Report to Sydney Central City Planning Panel

SCCPP reference	PPSSCC-135
DA No.	493/2020
Date of receipt	31 August 2020. Amended plans or revised/additional information received: <ul style="list-style-type: none">• 28.8.20• 30.10.20• 10.11.20• 21.5.21• 9.9.21• 10.11.21
Proposal	Construction of two residential towers comprising 708 apartments above the existing seven storey podium, the use of existing basement levels 1-5 for residential parking and various adjustments to the existing building to allow for the integration of those towers.
Street address	189 Macquarie Street, Parramatta
Property Description	Lot 1, DP 1214839
Applicant	Toplace Pty Ltd
Owner	JKN PARA Pty Ltd
Submissions	Less than 10 unique submissions
Relevant s4.15 matters	<ul style="list-style-type: none">• Environmental Planning and Assessment Act and Regulations• State Environmental Planning Policy No. 55• State Environmental Planning Policy No. 65• State Environmental Planning Policy (Sydney Harbour Catchment) 2005• State Environmental Planning Policy (BASIX) 2004• State Environmental Planning Policy (Infrastructure) 2007• State Environmental Planning Policy (State Regional Development) 2011• Parramatta Local Envir

Figure 8: Plan view of corridor treatment

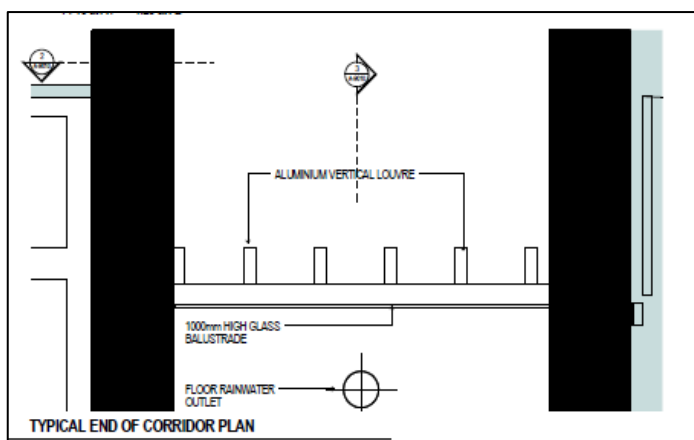
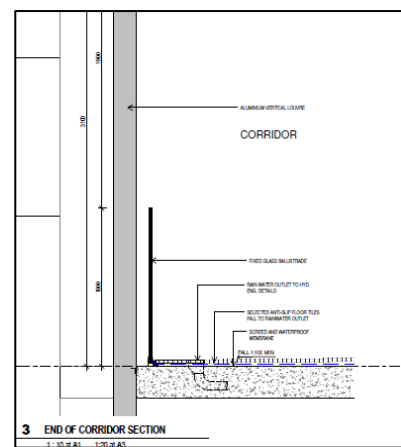
The justification for excluding these corridors from a GFA calculation is a design whereby the end of a corridor is "open to the weather" to allow for a semantic compliance with the LEP definition of 'gross floor area'. That treatment comprises fixed vertical louvres, independent from which sits a 1m glass balustrade, as shown below:

While it is acknowledged there would be certain genuine examples of where an external circulation corridor should be excluded from a GFA calculation, adopting that same approach for corridors which are essentially internal and proportionally insignificant within the overall façade, like those of this scheme, is a disingenuous design exercise which does affect building bulk, and provides a poor amenity outcome for residents.

Figure 10: Location of upturn screen

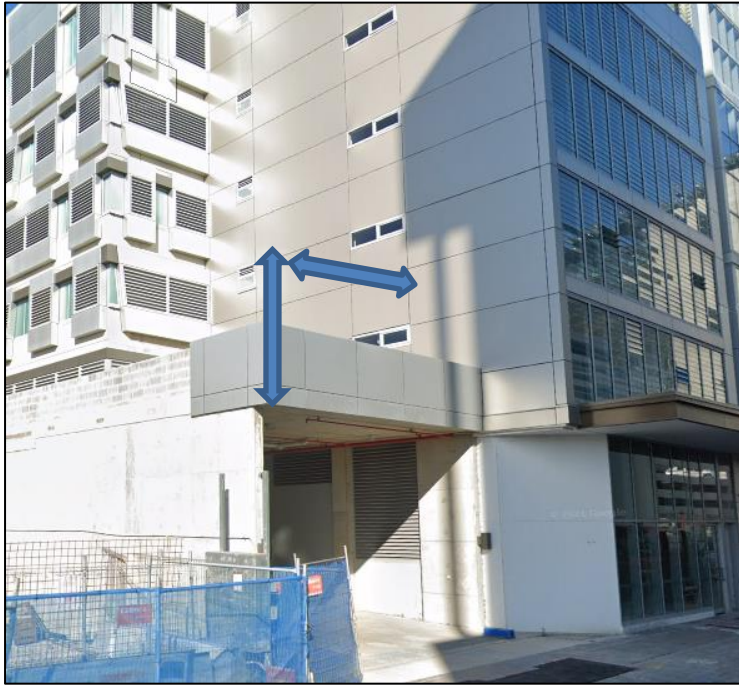
- Within the site
 - An impermeable upturn screen from the level 1 slab to the level 3 slab of part of

- the existing podium is required to mitigate wind conditions along Macquarie Street (at locations 12,13,14 and 18 – refer Figure 10 below)

Figure 11: Study locations 12,13,14 and 18 in red. Private property landscaping shown in yellow.

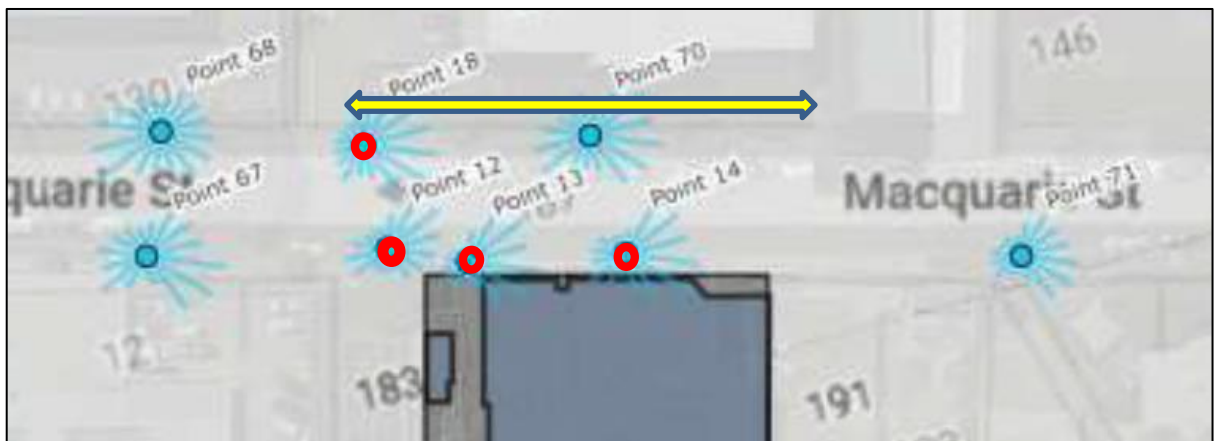
- Further, the street trees on the northern side of Macquarie Street have been removed, leaving only trees on private property.
- Study location 12 is shown to be on, but not over, the safety criteria. While there is debate as to whether such should be considered a pass or a fail, it is appropriate to err on the side of caution and categorise the outcome as a 'fail', consistent with relevant professional guidelines.

- The proposed mitigation strategies for study location 12 clearly involve a reliance on street trees for wind mitigation. Without those trees, using only the awning and upturn screen, the criteria is not satisfied. A similar outcome would be expected for locations 13 and 14.

Figure 14: Extent of 1% AEP flood event

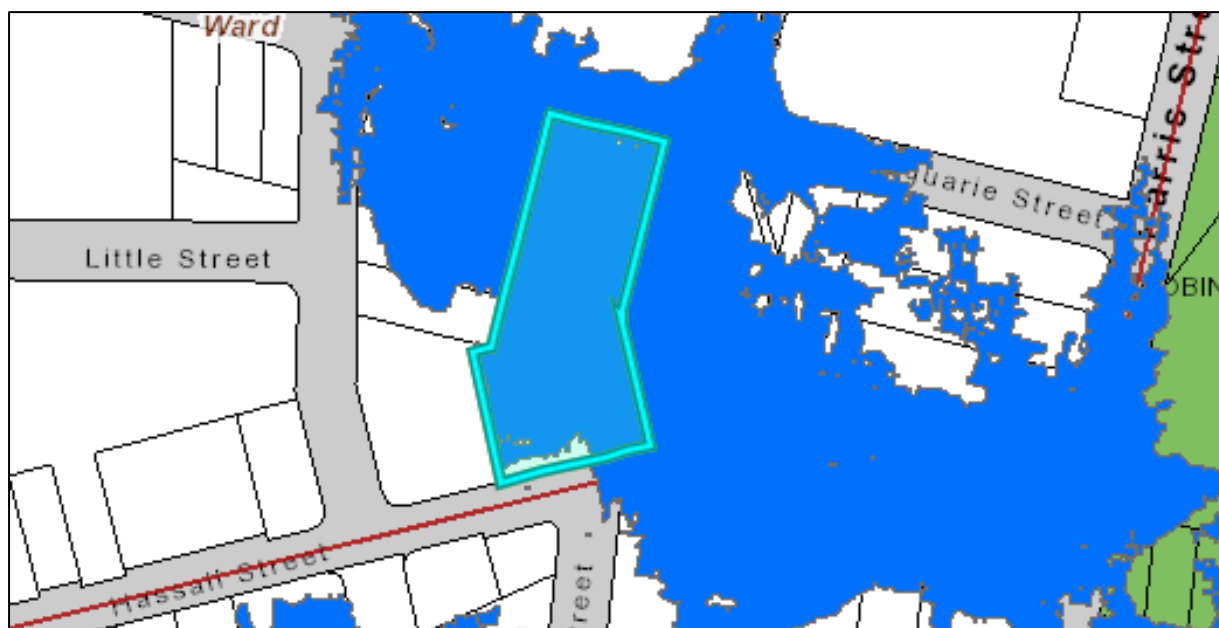
Almost the entire site is impacted by the 1% AEP flood event as shown at Figure 14, and completely inundated under a Probable Maximum Flood (PMF) event. The hazard level for the 1% ARI is categorised as 'high'. Flood impacts therefore represent a significant site constraint.

- The existing building is not constructed in manner consistent with the base building consent – that is - the Macquarie Street ground floor retail levels vary from the approved plans. The approved levels were to managing flooding
